March 26, 2024

**RE: 50 Los Gatos - Saratoga Road**

## ISSUES AND CONCERNS

## RECOMMENDATIONS

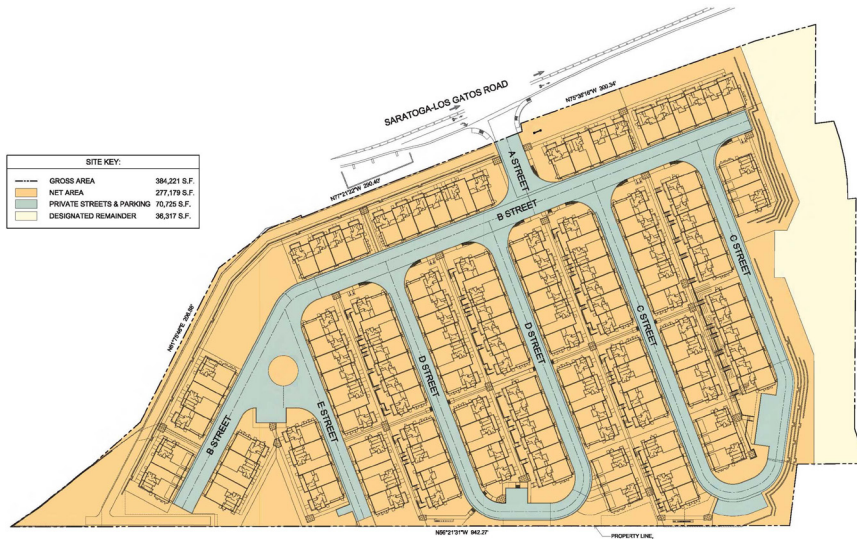
The proposed development plan may be permitted but is unlikely to result in a very livable neighborhood for its residents. Some of the issues include the following:

The proposed number and disposition of residential units is a plan to maximize the number of units but would likely not result in a cohesive neighborhood equivalent to others in Los Gatos. The site itself is substantially separated from other development in the community and will need to rely on its own development for parking and open space. Some specific issues are suggested below.

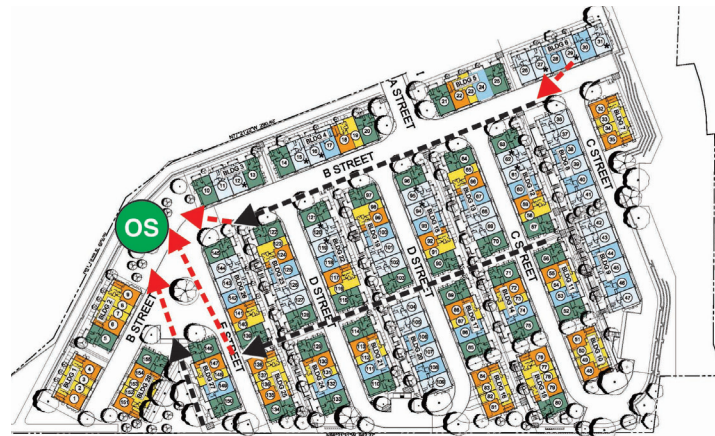
The amount of usable common open space is quite limited for a neighborhood of this number of residents and desired quality. It is also not very family and child oriented. Most of the distributed open space is located in the walkways between structures and not suitable for any active uses. The two larger concentrated open spaces are devoted to bioswales which can be visually attractive for passive viewing but usually not suitable for any active uses. I did not find enough information in the application materials to understand the more detailed uses and landscaping proposed for these areas. While the landscaped walkways leading to unit entries will likely be well landscaped, that is also primarily a visual rather than usable amenity - see photo example below of typical walkway for this type of development.

Pedestrian walkways along the entry walkways and passageways between buildings have the potential of being pleasant, continuous landscaped environments, but they are interrupted at the major western bioswale open space where residents must access the open space by walking along and across streets at awkward locations.

**Common open space is limited, remotely located to most units, has limited active use due to bioswale needs and dedicated pedestrian walkways are not fully connected**

### 3. Guest Parking

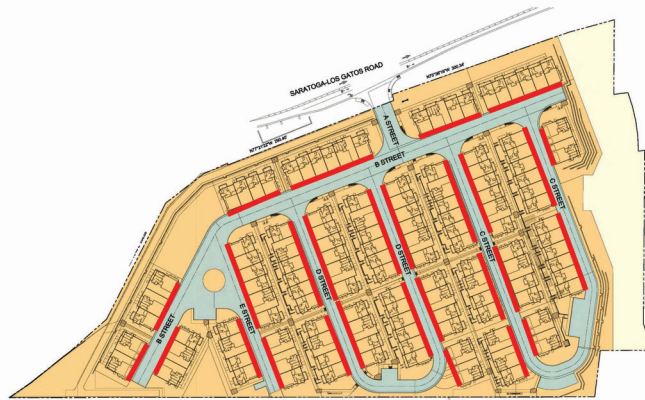
There are only 20 guest parking spaces provided for 155 dwelling units which is one space for every eight units. The spaces are all located on the southern edge of the parcel, far away from the bulk of the homes and not aggregated into interconnected areas. Finding a guest parking space will be difficult and then pedestrian walks to many units would be quite long. The relative isolation of this parcel makes access to any meaningful off-site parking impossible.

**Guest parking is limited to 1 parking space per 8 dwelling units and is inconveniently located**

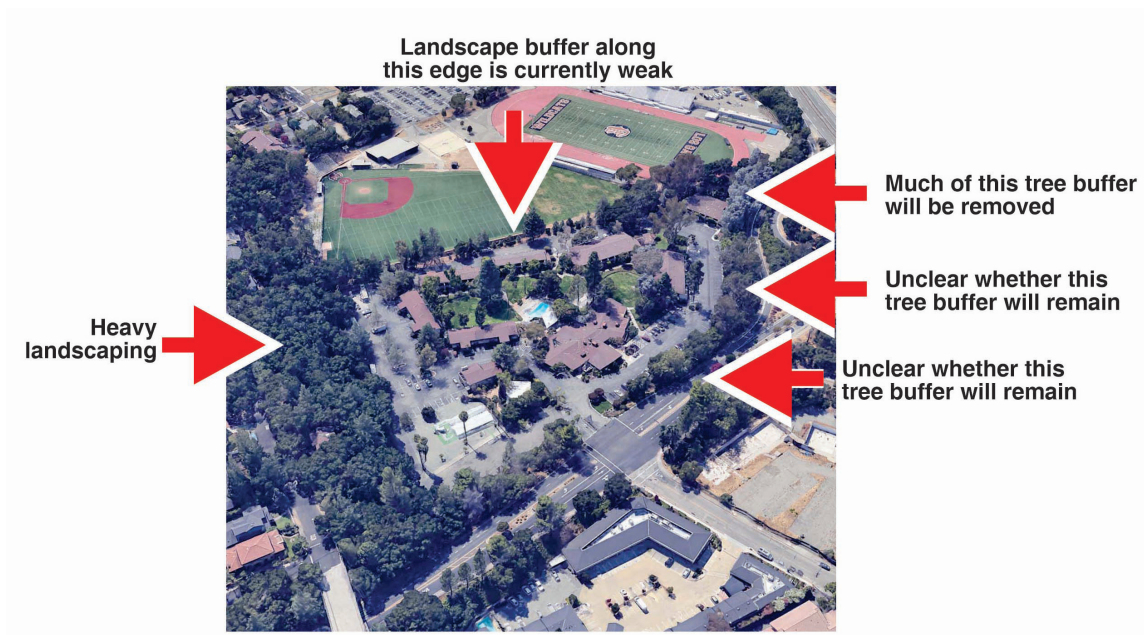
The street frontages experienced by both residents and visitors alike will be dominated by long rows of unit parking garage doors with limited variety or landscaped relief - see illustrations below.

All vehicular access is dominated by continuous garage doors with limited landscaping or facade variations

However, they are sited in rows of almost identical buildings with limited variety and color changes. While they are handsome individually, they may as a whole lend a barracks-like feeling and are unlikely to achieve the ambience of individual home identity that has been sought by the town in other multifamily residential developments. The lack of any building height variations contributes to the sameness of the buildings.

Northern edge adjacent to Los Gatos-Saratoga

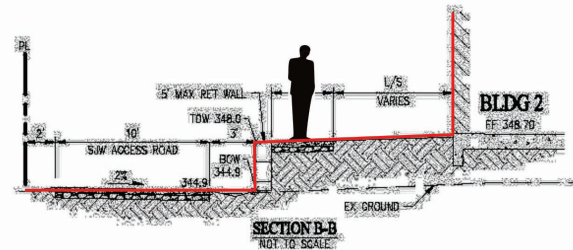
It is unclear from the drawings what the project edge conditions will be after development. The current edges have a great deal of mature landscaping that imparts a special character to the site. The engineering site edge sections below seem to show little potential for any significant retention or addition to that edge treatment. It would be desirable for the applicant to provide more information on the planned site edges - especially since they are immediately adjacent to many walkways leading to unit front door entries.
